Project: Q30150 Bacton Low Rise Estate Regeneration

Design Workshop 1

Project: Q30150 Bacton Low Rise Estate Regeneration

Figure 1

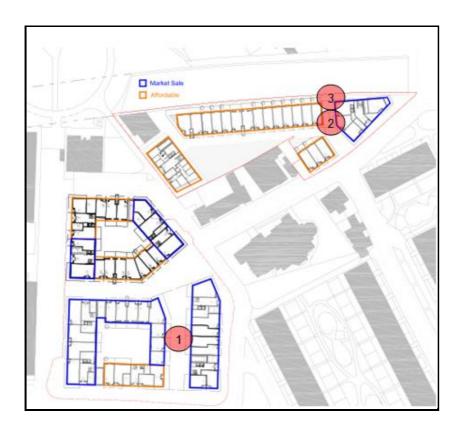
- 3. (See Item 1, figure 1 on page 7) Agreement amongst team that this is a key part of the site with many issues. PK confirmed that there would be no B1 use at this location; any B1 will be located within the northern block on Haverstock Road. Here there will be a mix of residential units. Architects have changed the drawing slightly since last meeting to create more links to maintain street views. Model being created by the architects at the moment will show this well.

- 4. EJ showed concern over the treatment of the space located at item 1, figure 1. PK explained that the other green spaces worked as garden squares whereas this space will have harder landscaping and a character similar to a mews. EJ asked if the residential units here would be using the land at item 1, map 1 as private external space. PK answered that there would be a subtle line demarcating private and semi-private space, instead of actual patio gardens or defined back gardens. The space would have a more continental feel.

- 6. At (item 2,figure 1)- PK suggested that this space would provide an entrance to the DHO part of the development, and would include an attractive treatment, such as a low wall or attractively-designed gate to subtly differentiate the public from semi-private space. EJ noted that this space is symmetrically laid out but he raised concerns that it did not have a clear function. SM said that it has a clear sense of enclosure, created by surrounding buildings on three sides and the mature trees on the fourth side. He said that it could become a garden area for residents. JF noted that this space is not large enough for another dwelling and that the trees take up a large proportion of this space. PK said that the landscape treatment of this space would be considered further.

- 7. At item 3, figure 1- EJ said that there was a risk of this space turning into dead space as it was just an area/route to nowhere. EJ suggested that there could be single storey unit here linking the two buildings. This would be better acoustically.

- 9. EJ noted said that he thought that gates across the centre of the space here would seem too aggressive and over the top and suggested that to have a gate at the natural bottleneck may be more appropriate. He said the team will therefore need to find a way to make this large area useful. He added that this was not to say that the Council consider that gates are definitely appropriate.
